SonarIQ

Project Demo ship ▲ Revision Rev B ▼ 0R-117 · 14:36

Inbox

Demo ship · Rev B · sent from FreeCAD 14:43 · sonariq_rev-b.bcfzip

Stair 3B · Decks 4–7 · Deck 5

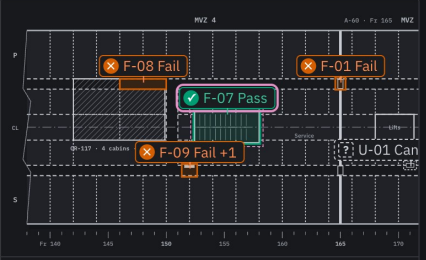
Stair 3B is narrower than the people it serves need

> Stairway clear width shall not be less than W, worked out from the persons served on each deck the stair connects.

REQUIRED	MEASURED	MARGIN
1,380 mm	1,350 mm	−30 mm

$$W = (N_1 + N_2 + 0.5\,N_3 + 0.25\,N_4) \times 10\ \text{mm}$$
$$= (\,68_{N_1\ D5} + 44_{N_2\ D6} + 0.5 \cdot 40_{N_3\ D4} + 0.25 \cdot 24_{N_4\ D7}\,) \times 10$$
$$= (68 + 44 + 20 + 6) \times 10 = 138 \times 10 = \mathbf{1{,}380\ mm}$$

Highlighting in 3D: Deck 5 · 68 persons: 60 before OR-117, + 8 berths in the four new cabins.

SQ **Rule engine** found F-07 after OR-117 (cabin block × 4, 8 berths) 14:32 · Rev B
Fail required 1,380 mm · measured 1,350 mm · margin −30 mm · Rule engine

AL **Aino Laine** Outfitting designer sent to review 14:43 · Rev B
> Margin is 10 mm. Any new berth on Decks 4–7 will reopen this.

AL **Aino Laine** Outfitting designer applied fix 2 from FreeCAD 14:36 · Rev B
> Keep four cabins, one berth each. N_1 68 → 64 on Deck 5. Change order OR-117.

SQ **Rule engine** re-checked 14:36 · Rev B
Pass 1,340 ≤ 1,350 mm · margin 10 mm · Rule engine

Demo ship · Deck 5 · top view · Rev B · measure: Fr 152 · S

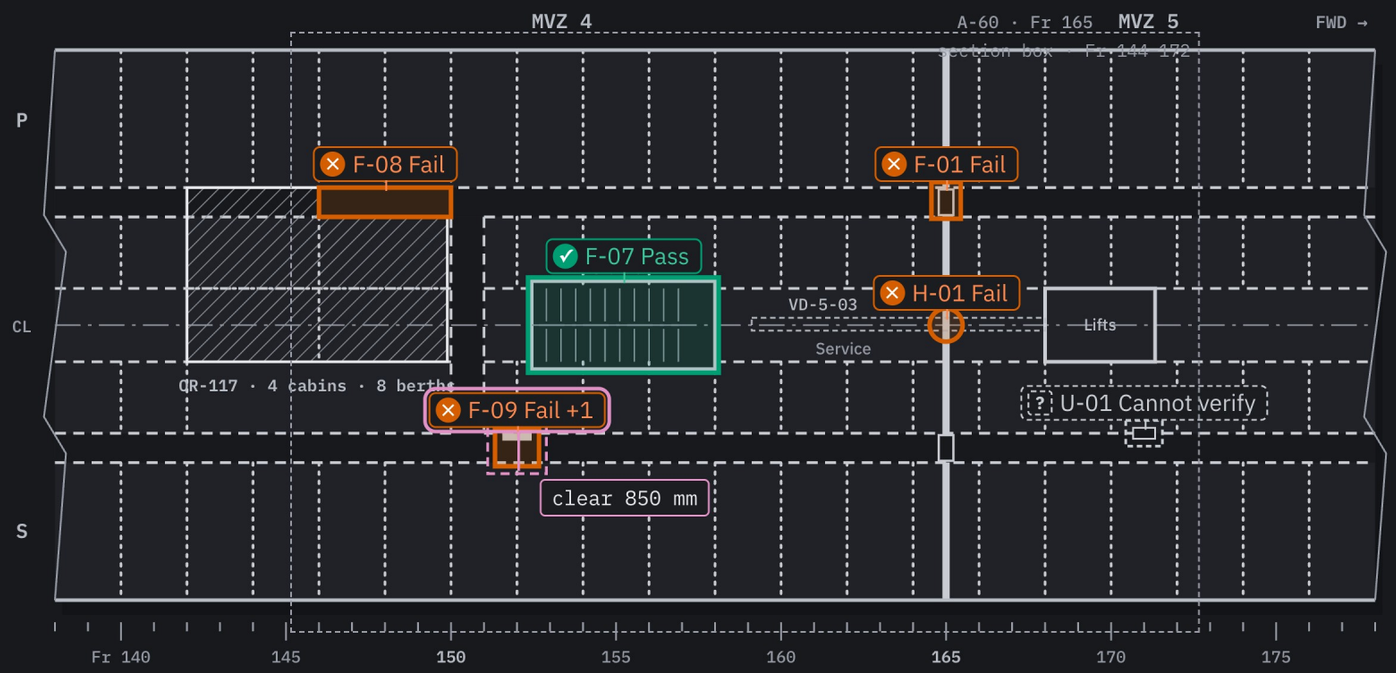
Fail — F-01 FD-5-165P below bulkhead class
A-0 fitted · A-60 required

Fail — F-08 Dead-end corridor
4.2 m deep · 1.2 m wide · awaiting approval

Fail — F-09 Corridor pinch
850 mm · required 900 mm

Fail — H-01 VD-5-03 without fire damper
crosses A-60 MVZ bulkhead · Fr 165

Warning — W-01 Corridor below guideline
850 mm · guideline 915 mm (36 in)

? Cannot verify — U-01 D-5-171-S has no fire class
add the property or confirm

Pass — F-07 Stair 3B
1,340 ≤ 1,350 mm · fix 2

RCRV · Deck 02 · top view · units in · measure: D-02-114

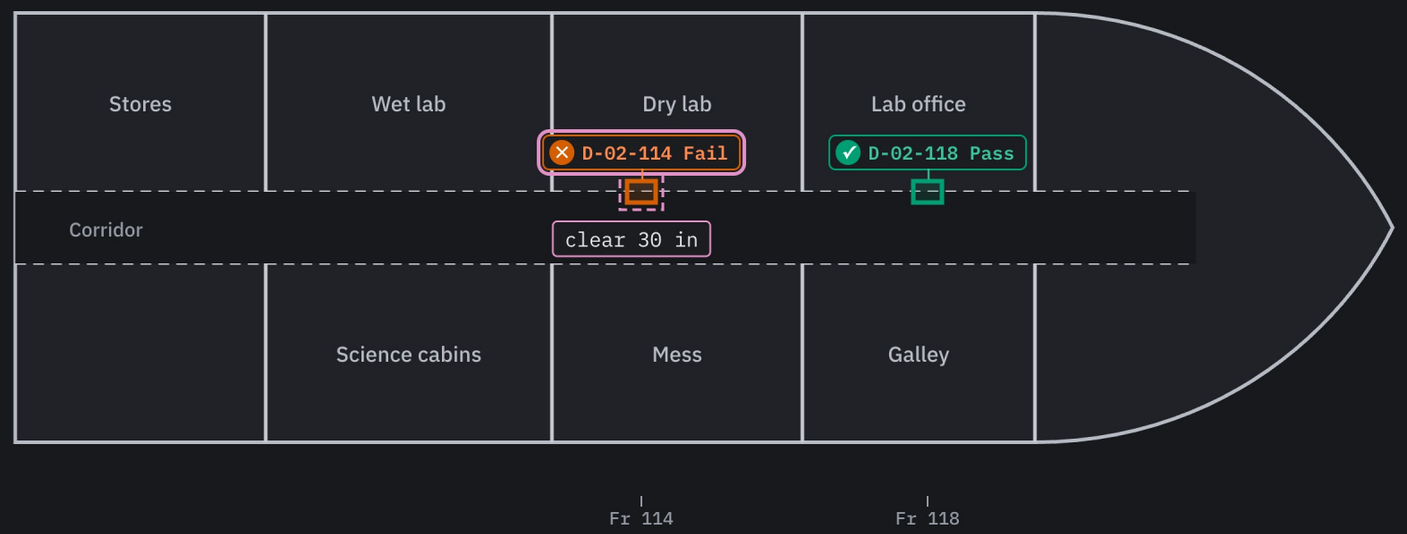
Fail D-02-114 **Door clear width**
30 in · required 32 in (762 / 813 mm) · ADA 2010 §404.2.3

Not applicable
SOLAS II-2/9.2.2.1.1
MVZ bulkhead and door integrity · passenger ships > 36 passengers

Not applicable
SOLAS II-2/13.3.1.2
Dead-end corridors · passenger ships > 36 passengers

Not applicable
FSS Code Ch.13 §2.1.2
Stair width from persons served · passenger ships > 36 passengers

Rev A → Rev B

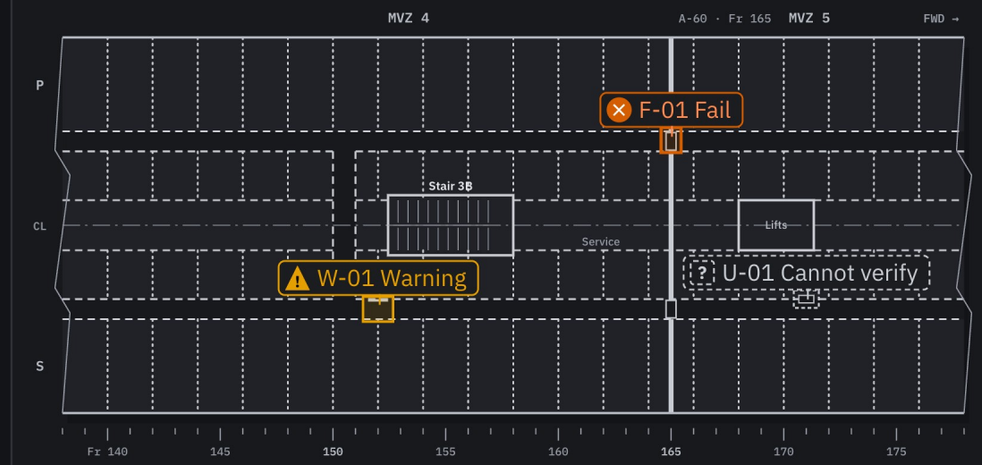
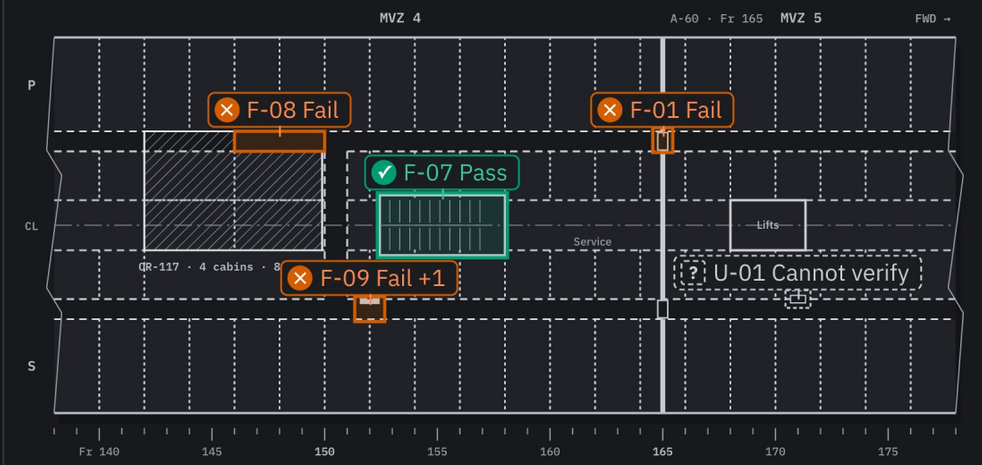
F-07	Stair 3B · Decks 4–7	Pass → Pass	1,300 → 1,380 mm Fail at 14:32 → 1,340 mm Pass at 14:36 (fix 2)
F-08	Dead-end · Fr 146–150 · P	Pass → Fail	depth 4.2 m > width 1.2 m · accepted with reason, awaiting approval
F-09	Corridor pinch · Fr 152 · S	Pass → Fail	clear width 900 → 850 mm · required 900 mm
W-01	Corridor guideline · Fr 152 · S	Warning → Warning	900 → 850 mm · guideline 915 mm · status unchanged

COR-5-146-P — reshaped
closed at Fr 146 · open end at Fr 150 · now a dead-end

COR-5-152-S — reshaped
clear width 900 → 850 mm at Fr 152

Stair 3B — not edited
geometry unchanged · N_1 60 → 68 → 64 · re-checked because Deck 5 berths changed

Cabin block × 4 — added
Deck 5 · aft of Fr 150 · 8 berths at 14:32 · 4 berths after fix 2 · OR-117
